Case #H-94-168. 431 Arroyo Tenorio. Downtown and Eastside Historic District. Debi Sanchez proposes an addition on east elevation; yard wall construction.

DATE: 11 October 1994
TO: Historic Design Review Board Members
FROM: Mary Grzeskowiak, Planner III *Mg*
VIA: Dennis Thompson, Planning Division Director *mjl
FOY
DT*

CASE #H-94-168 ADDRESS 431 Arroyo Tenorio

WEST ELEVATION
H-94-168
431 Arroyo Tenorio

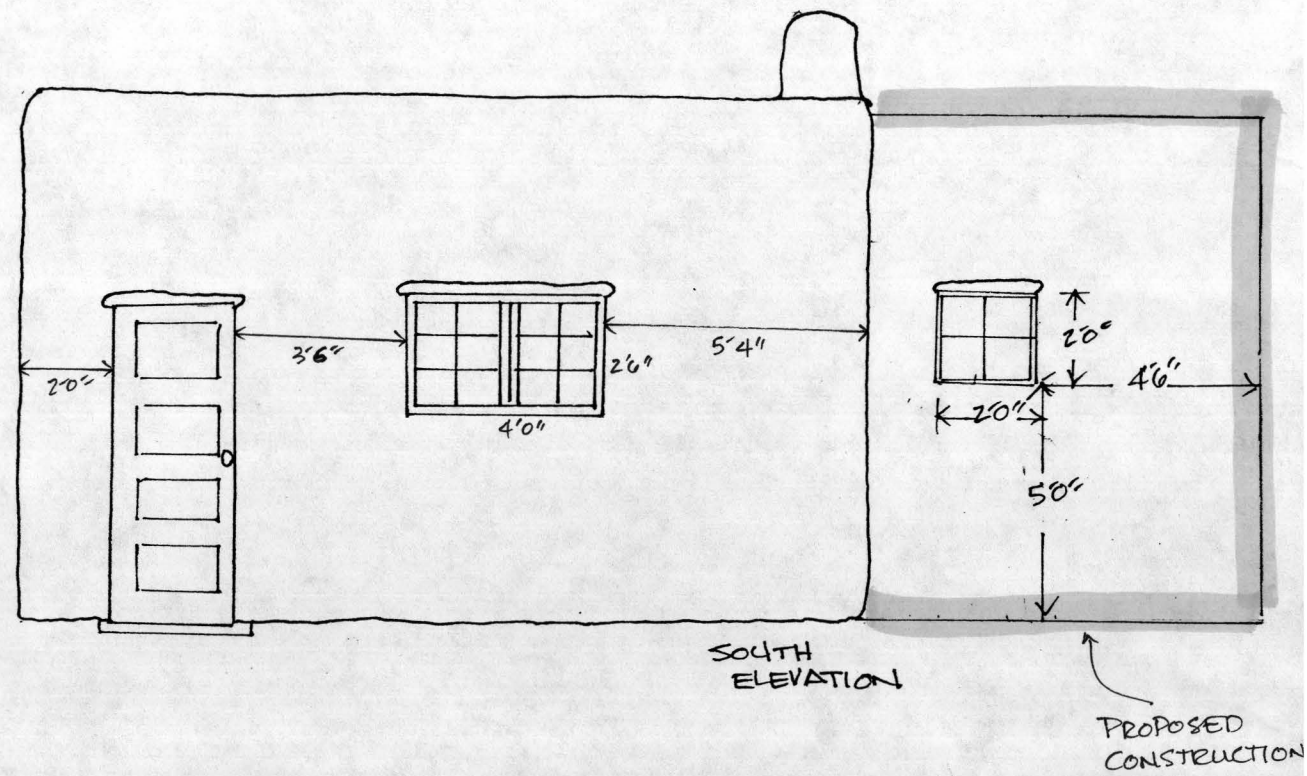
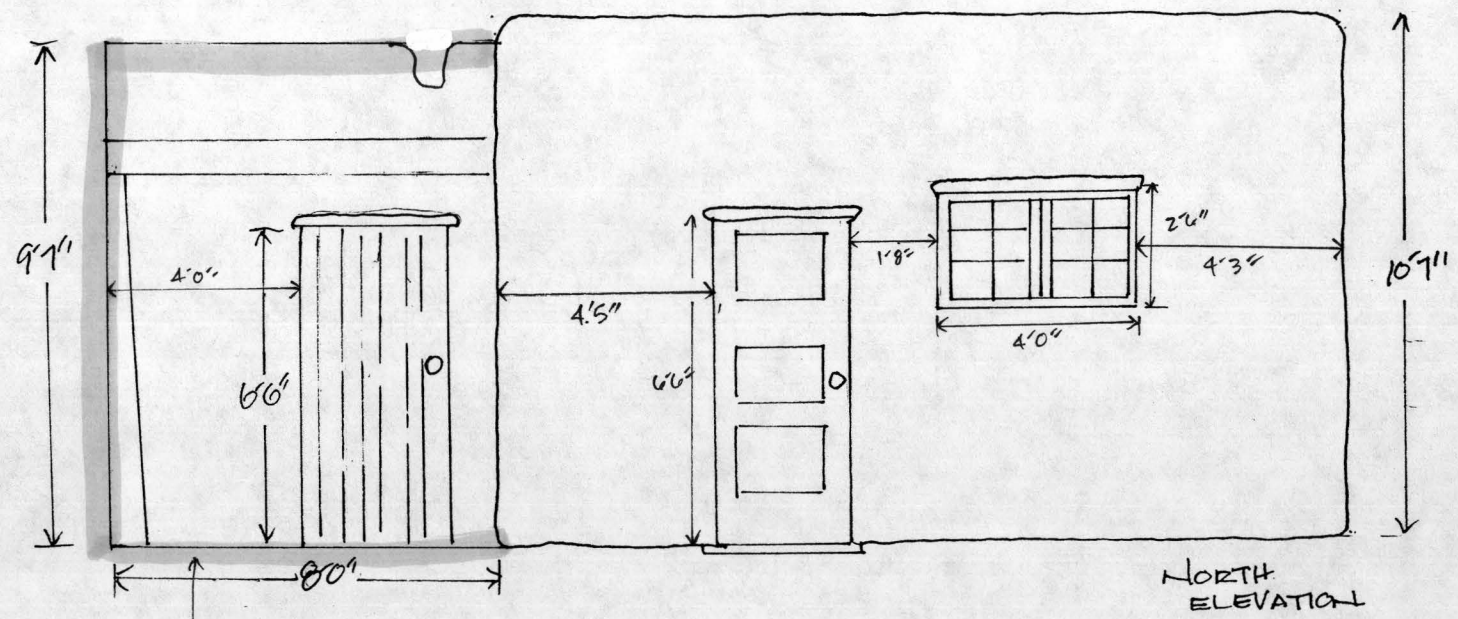
The applicant has illustrated an addition on the east elevation of the historic structure on the subject site. The addition, which houses a closet and entry area to the residence will be finished to be in keeping with the existing architecture of the building. Its height is kept below the height of the existing building by 1 foot so as to distinguish it from the exiting. As well, the proposed addition includes a portal which is detailed with simple features such as a post and lintel which supports a flat parapet with canale.

Staff presumes the primary facade of this structure to be that which faces Arroyo Tenorio. With the HDRB's concurrence on this matter, staff notes that the historic preservation standards in the SFCC have been met with regards to placement and design of the addition. As a result, staff recommends approval.
